The Energy from Waste (EfW) [SSD 6236] proposal by The Next Generation (NSW) Pty Ltd [TNG] has been on public exhibition.

Various submissions were received. The proponent provides a response to the following letter received as part of the public exhibition.

- Letter from Office of Environment and Heritage (DOC 15/168903 SSD 6236) (21 July 2015)

Response to OEH - Biodiversity

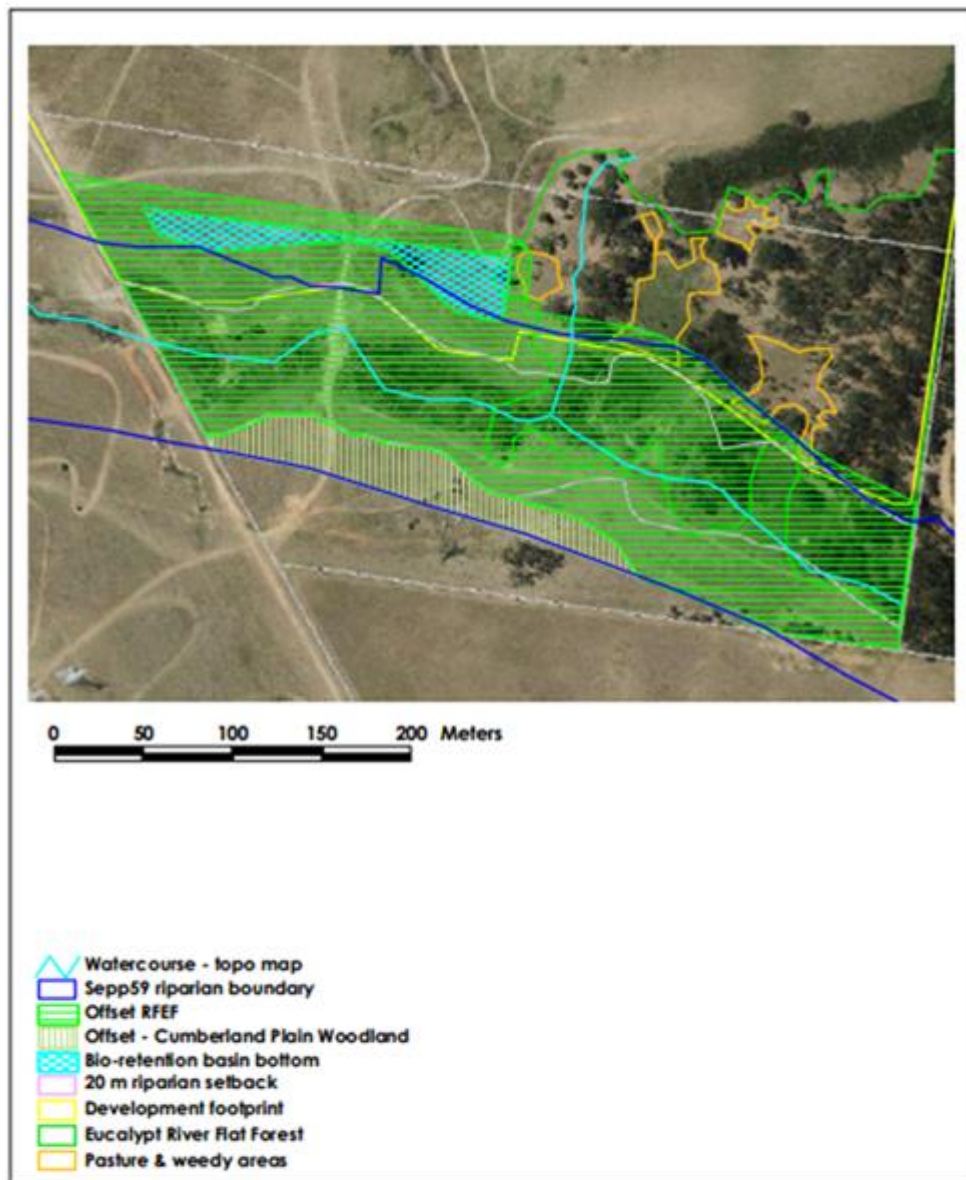
The area available for development is bounded in the south by a designated creek and riparian zone in which development is prohibited. This is shown on the following figures.

Figure 5: Existing vegetation and proposed revegetation are (in green).

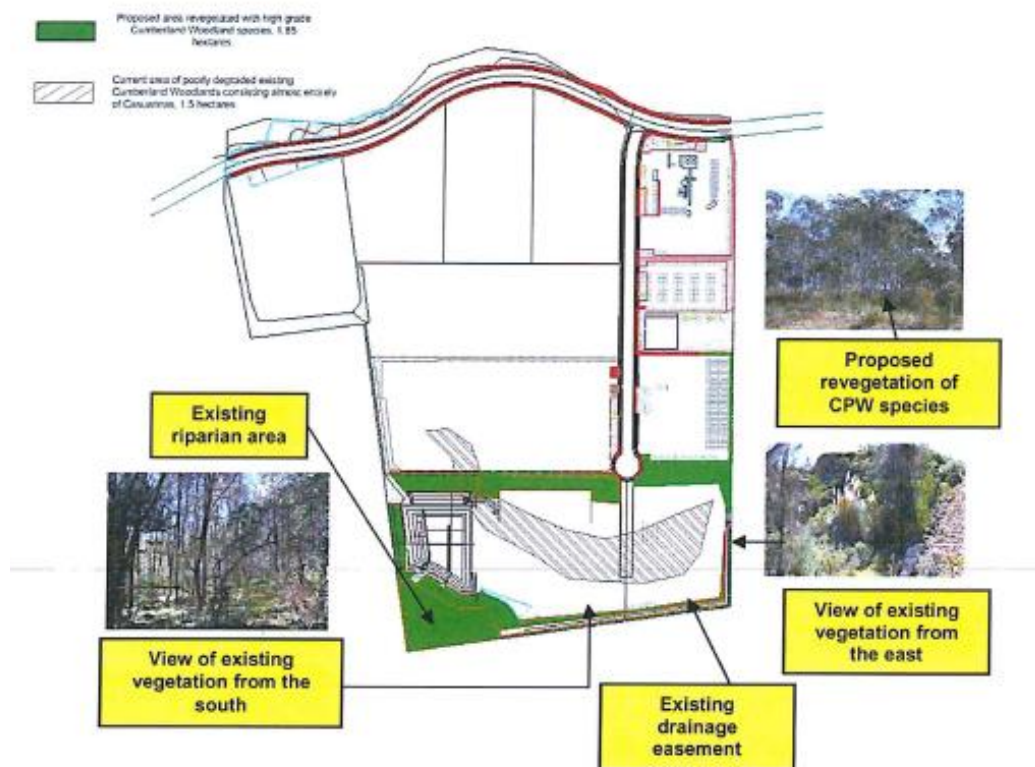
- **revegetate 1.85 ha of the site with Cumberland Plain Woodland (see Figure 5);**
- **develop a management strategy for the enhancement of the riparian corridor vegetation in the south west corner. The riparian area would be fenced and segregated from the construction works and future operations, weeds removed and natural regeneration encouraged; and**
- **maintain the riparian area in perpetuity through a public positive covenant.**

- Revegetate 1.85Ha of its site with Cumberland Plain Woodland (next figure)
- Develop a management strategy for the enhancement of riparian corridor vegetation in the south west corner.
- The riparian area to be fenced and segregated from the construction works, weeds removed and natural vegetation regenerated and maintained and
- To maintain the riparian area in perpetuity through a public positive covenant,
